**TOWN OF NEWBURGH
PLANNING BOARD
TECHNICAL REVIEW COMMENTS**

PROJECT: NYCDEP DELAWARE AQUEDUCT RONDOUT WEST BRANCH
TUNNEL REPAIR SHAFT 5B - STORM WATER POLLUTION
PREVENTION PLAN MODIFICATION #6
PROJECT NO.: 11-15
PROJECT LOCATION: SECTION 8, BLOCK 1, LOT 15.2 & 22.2
PROJECT REPRESENTATIVE: NYCDEP
REVIEW DATE: 25 SEPTEMBER 2015
MEETING DATE: 1 OCTOBER 2015

Re: New York City Department of Environmental Protection
Delaware Aqueduct Rondout-West Branch Tunnel Repair Program
West Connection Site / Shaft 5B and Support Site
Stormwater Pollution Prevention Plan – Modification #6
Town Project Number: 2011-15

**Response to September 1, 2015 Comments
September 14, 2015**

SITE DRAINAGE PLAN FINAL RESTORATION
 SCALE: 1"=100'

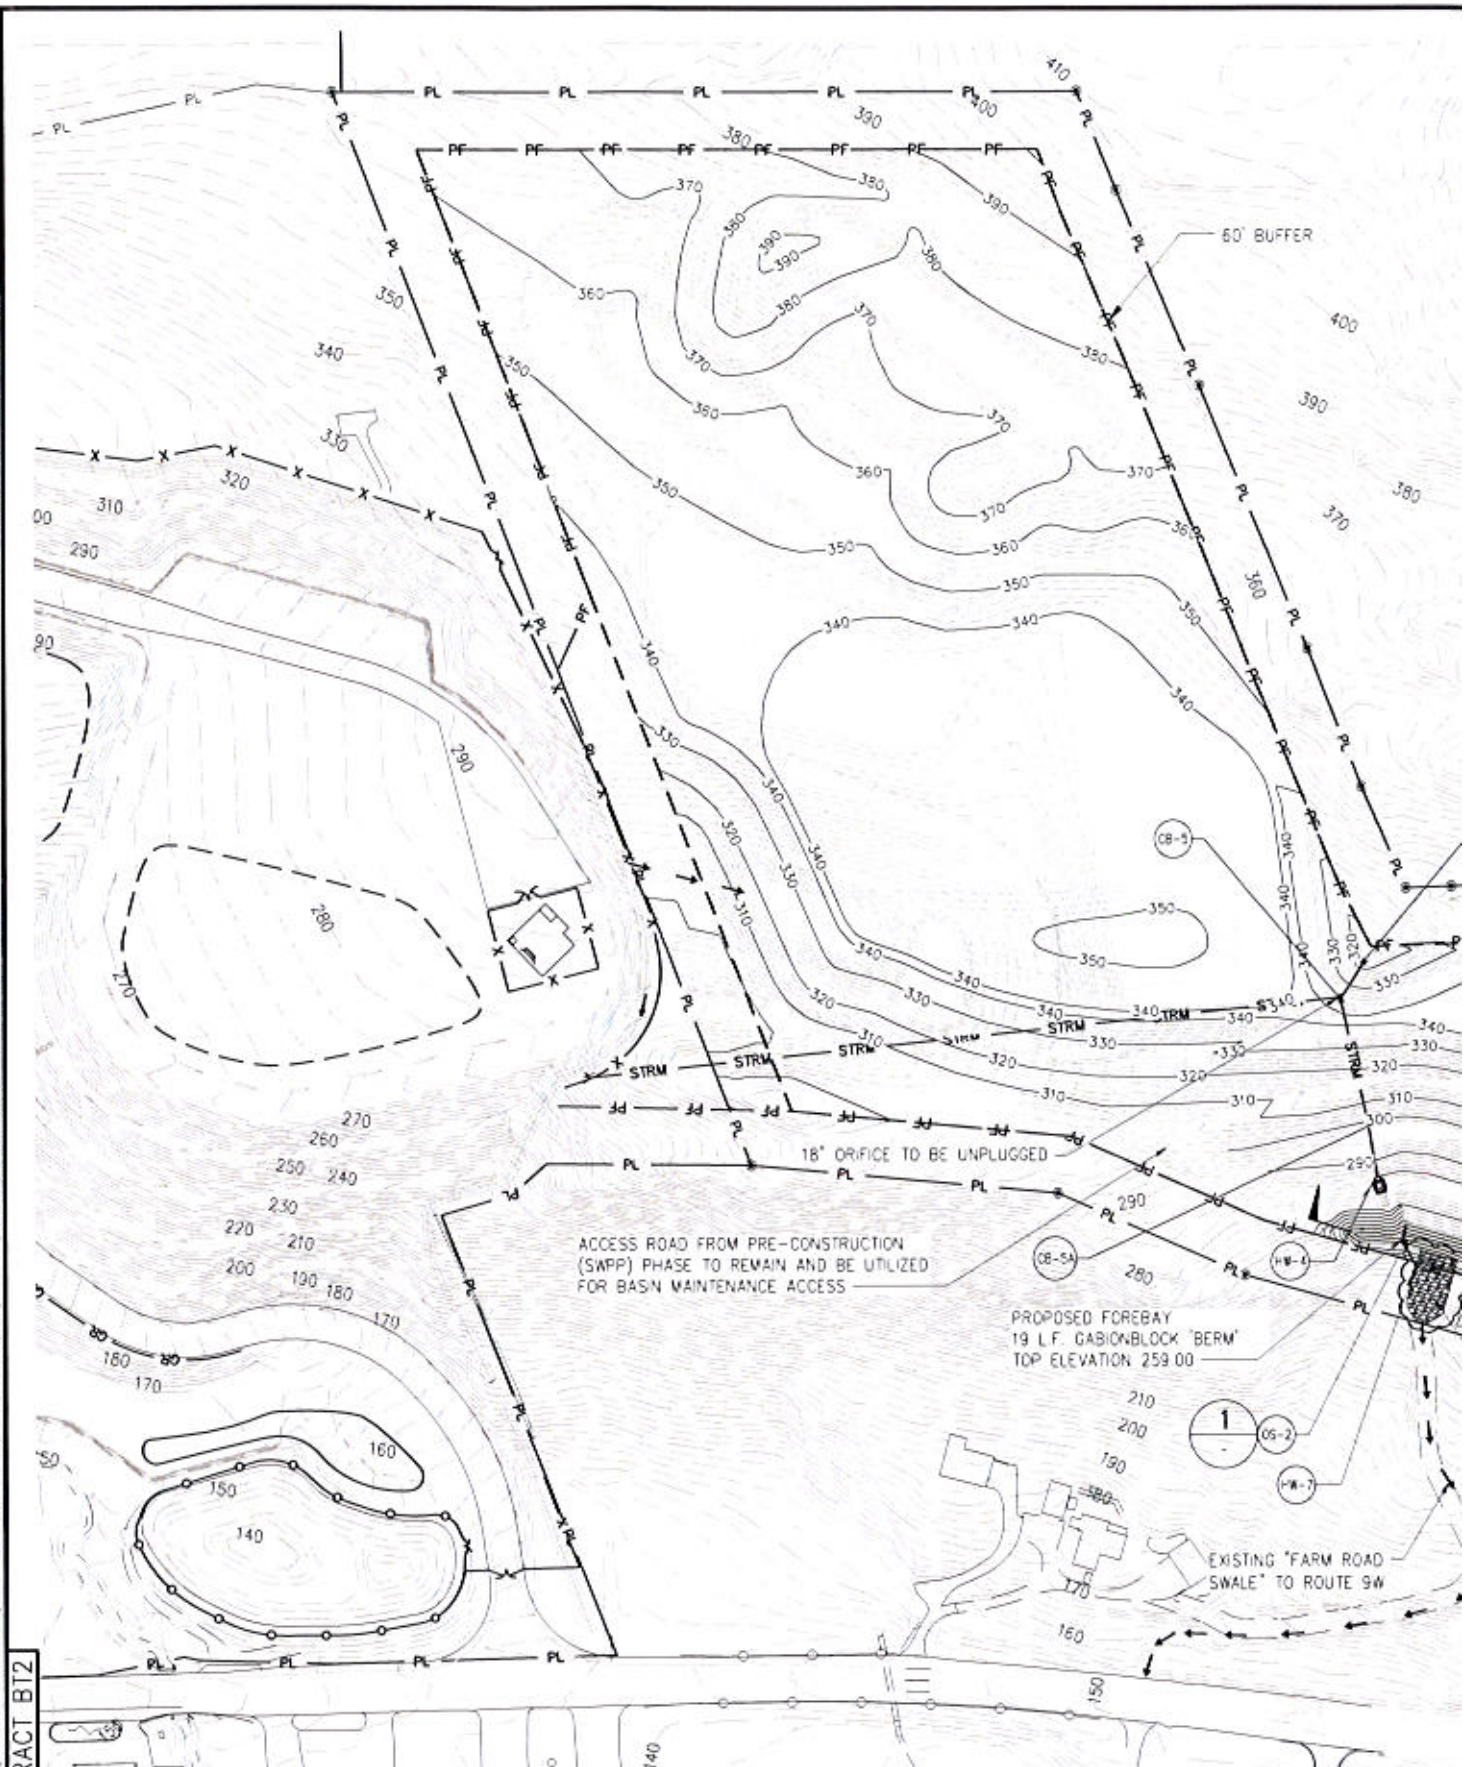
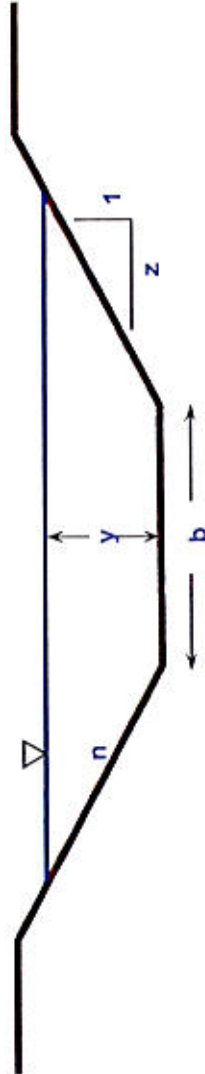
- 4) **Final plan submission should depict drainage course from SWDP2 to the new Route 9W culvert system. Existing topography does not clearly define defined swale along the farm roads/drainage course.**

DEP Response: *The requested depiction of the farm road swale drainage course has been added to the SWPPP. Please see the attached half size drawing SWFP-C2-120 as well as excerpts from Appendix F. Additional information from the SWPPP preparer follows below.*

"The farm road swale has been field verified and dimensions of which are provided in the stormwater calculation package contained within Appendix F of the SWPPP (pages 56 and 58 of the pdf). These dimensions were measured both downstream of the SWDP-2 discharge point and 50 feet downstream of the discharge point. The riprap armoring shown in the drawings and in various figures within the stormwater report is being installed to protect the existing slope from eroding from the proposed point discharge from basin SWDP-2 while water flows to the existing swale. The rip rap armoring alignment provides a direct connection with the existing swale. At this connection point, based on field observations, the road cross-section is concave. This begins the swale cross-section geometry until further down the road, where the swale begins to run along the side of the road. In figures 9 and 10 of Appendix F (pages 48 and 50 of the pdf) the topography and flow lines are shown from the SWDP-2 discharge point flowing towards Route 9W. This flow line has been added to drawing sheet SWFP-C2-120 as well and shows the entirety of the flow line from the discharge point to Route 9W, where flow is intercepted by the existing highway drainage system."
